ZONING ADMINISTRATOR'S REPORT
VARIANCE APPLICATION
1154 E. Mifflin Street

Owner: Gene W. Blabaum

Madison General Ordinance Section Requiring Variance: 28.047(2)

28.172 - RESIDENTIAL BUILDING FORMS.

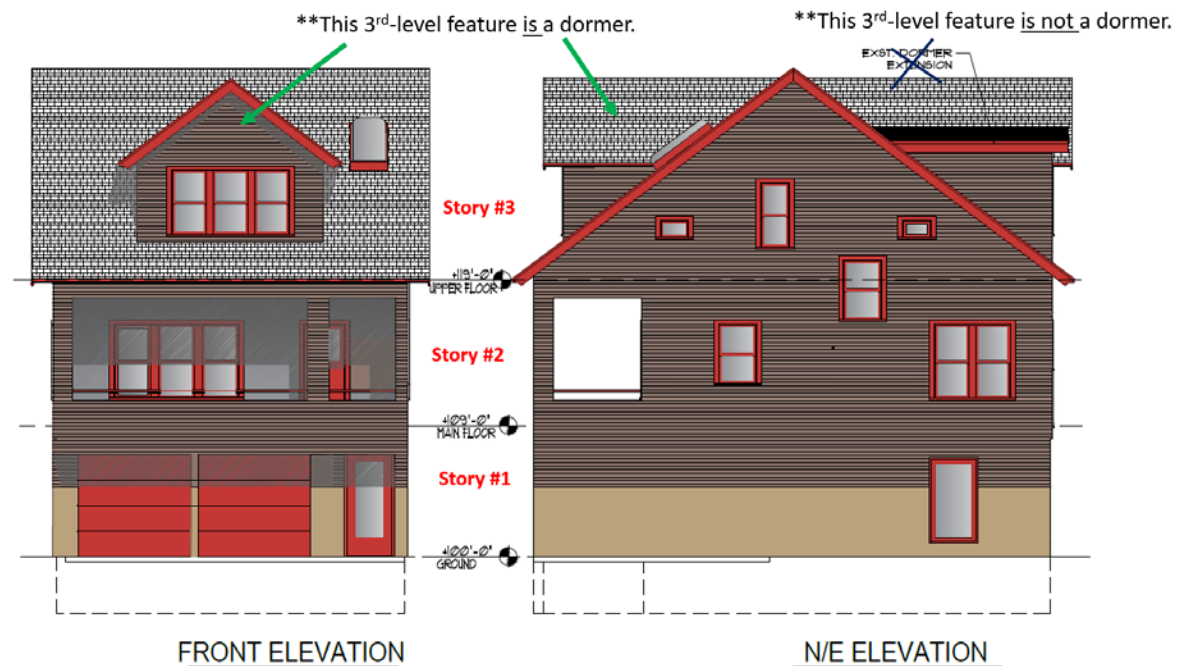
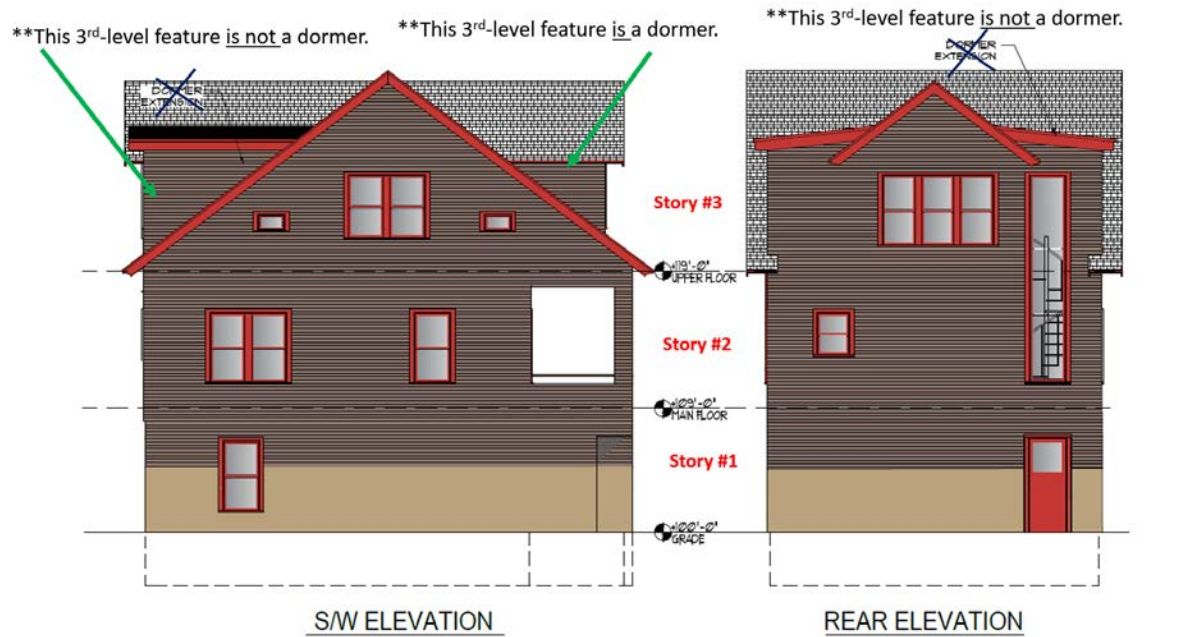
The subject property currently is classified as a two-story dwelling, and is under 35' in height. The structure has a typical original basement, mostly underground and partially exposed behind the front porch, a first-level living area, and a second-level living area under roof, with gable dormers facing front and rear, and a rear- left shed expansion off what appears to have originally been a

rear gable dormer (this is not classified as a dormer per current code). The new basement level is exposed over 50%, resulting in this level counting as a story. Existing levels of the building all shift up about five to six feet, to allow for the new basement story. Existing elevations have not been provided to verify the height increase.

The existing rear shed roof off the right side of the original rear gable dormer is not considered a dormer, and the proposed new shed roof off the right-side of the existing rear gable dormer similarly is not a dormer. All aspects of the rear 3rd level construction are not considered dormers.
